23rd September 2020

Re: Additional Information Response - DA2020/0770 for Subdivision of 1 lot into 2, alterations and additions to a dwelling house and secondary dwelling including swimming pool and change of use at 26 Riverview Road AVALON BEACH

Original Site Plan

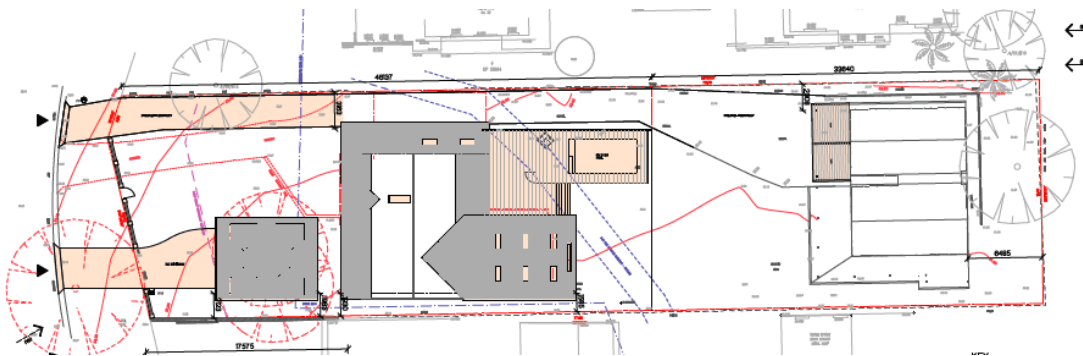
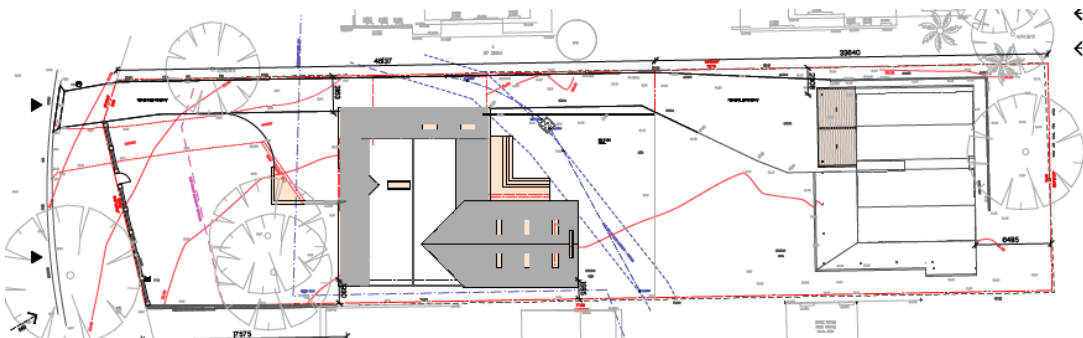
1. Council will only permit one vehicular crossing for the proposed two lots as the site frontage is less than 30m. The proposed two vehicular crossings are not permitted.

2. An overland flow study report shall be submitted to Council for assessment. The report shall demonstrate overland flow path within the updated drainage easement. Please refer to Council's stormwater Team's email for more details in regards to the requirements of the updated drainage easement.

3. Council's stormwater Team suggests objection to the proposed structures over Council pipeline, details shown in the email.
4. The three trees identified for removal comprise part of a broader local occurrence of Pittwater Spotted Gum Forest Endangered Ecological Community (EEC) and are significant healthy specimens with high retention value. The proposal to remove these trees to facilitate an additional driveway for the new subdivided lot indicates that the abovementioned controls have not been considered at the design stage. Moreover, whilst the arboricultural assessment (Growing My Way Tree Consultancy, June 2020) suggests that the removed trees are proposed to be replaced on a 1:2 basis, this is not indicated in the submitted landscape plan or Statement of Environmental Effects (SEE). The landscape plan is also noncompliant with PDCP Clause B4.7 (i.e. no net loss of native canopy trees and new landscaping to be at least 80% PSGF EEC), while the SEE fails to include reference to or assess compliance against relevant biodiversity provisions.

The proposal is therefore considered to be inconsistent with the controls and cannot be supported. Any future development application should seek to demonstrate that the proposal has been designed and sited to avoid impact to existing native vegetation. Further assessment against the Biodiversity Conservation Act in the form of a 'Test of Significance' may also be required should native trees be proposed for removal.

As a result of the issues raised by Council the owner has revised the plan with the following changes to mitigate the concerns raised by Council:

- Remove the second driveway and garage for the front lot to retain the existing trees
- Remove the swimming pool and decking area over the easement
- Provide a hardstand area for off street parking for the front lot.

It is considered that the proposed amended plans address the concerns from Council and result in a better planning outcome for the dwelling and the wider community. It is noted that the size and design of the dwellings remain unchanged aside from the removal of the swimming pool area and therefore there is minimal impact on neighbouring properties and therefore it is requested that re-notification should not be required.
